New Albany Architectural Review Board Meeting Agenda
Monday, August 10, 2026, 7:00 p.m.

ARB-36-2026 6905 Central College Road New Build Certificate of Appropriateness and Waivers

ARB-51-2026 4675 Reynoldsburg New Albany Road Certificate of Appropriateness

New Albany Architectural Review Board
Monday, July 13, 2026 Meeting Minutes - DRAFT

Image: Proposed site layout, showing the buildings, pavement and parking, and general landscaping.

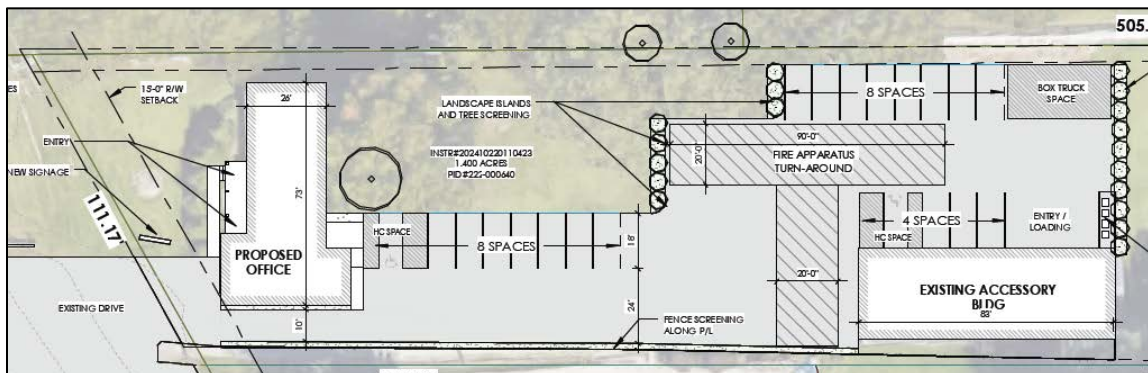
1. Provide evidence that all existing private well and septic systems have been abandoned in accordance with all applicable environmental regulations.
2. Show how water and sanitary service will be provided.

3. Show ODOT Limited Access right-of-way on the plans and advise if an ODOT permit is required to support the project.
4. Provide a fire truck turning radius analysis and obtain Fire Department approval.

5. Show major flood routing on the grading plan and design the driveway so that most of the runoff is directed away from the public road.
6. Show stop signs and stop bars at the driveway curb cut and add site distance triangles. Remove impediments to motorist view.

7. Work with staff to determine what improvements are required in the public right-of-way to support the project.
8. Add a table showing parking stalls required and provided and ADA stalls required and provided.

9. Provide a photometrics plan.

1. The parking lot pavement shall be at least five feet away from the southern property line.
2. All landscaping requirements shall be met.
3. At least two of the three proposed evergreen trees shall be deciduous canopy trees.
4. A bike rack shall be installed on the site.
5. The Engineer's comments regarding both the final development plan and Traffic Access Study shall be addressed by the applicant.

REAR ELEVATION
SCALE: 3/16" = 1'-0"

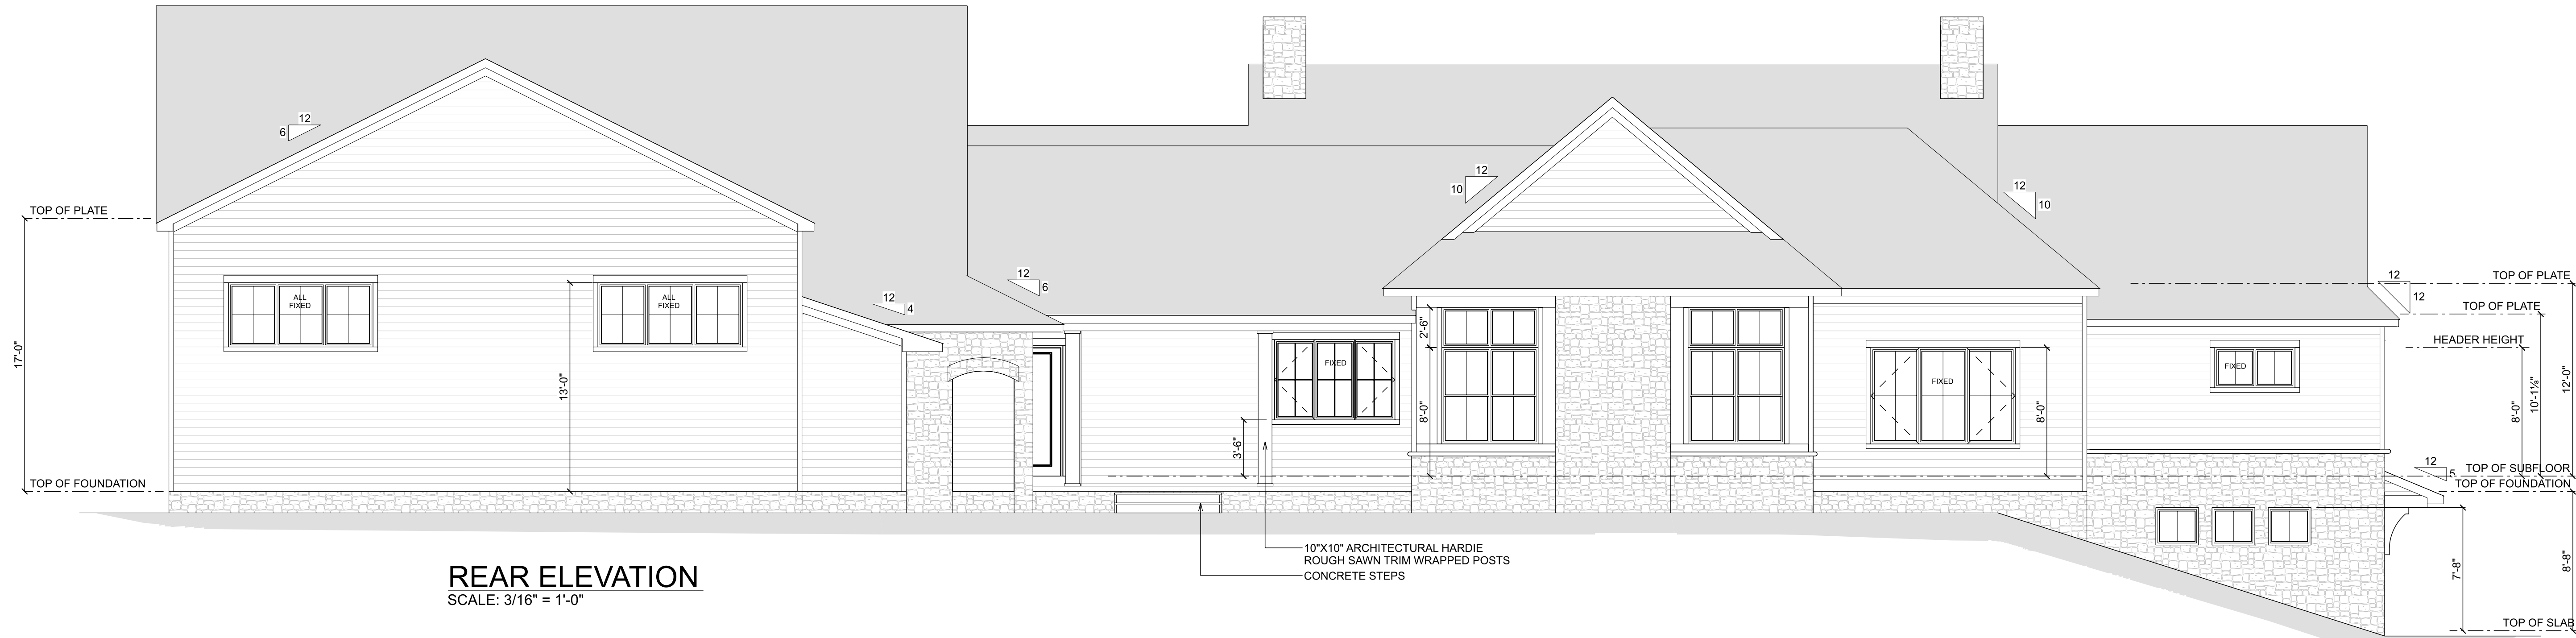
- The applicant has added a turned gable at the end of the garage, running in the same direction as the main house mass. The new gable allows the overall garage mass to be reduced while “breaking up” the formerly long façade into elements with a more human scale. This gable allows the garage to appear more comparable and cohesive with the main house mass.

- Windows have been added to the frontmost façade on the garage, facing the public right-of-way. As supported by the DGRs, the windows give this portion of the house the appearance of being “lived in;” the garage mass feels more human-scaled and as an active part of the rest of the house.

- In the original application, the massing of the forward-facing garage was large, bulky, and architecturally unrelated to the main house form and appeared to dominate the rest of the building. The city architect states that he believes the new composition is the correct approach, as it allows the garage to be a cohesive part of the architectural strategy. See waiver A for more specific descriptions of the updates to the garage.
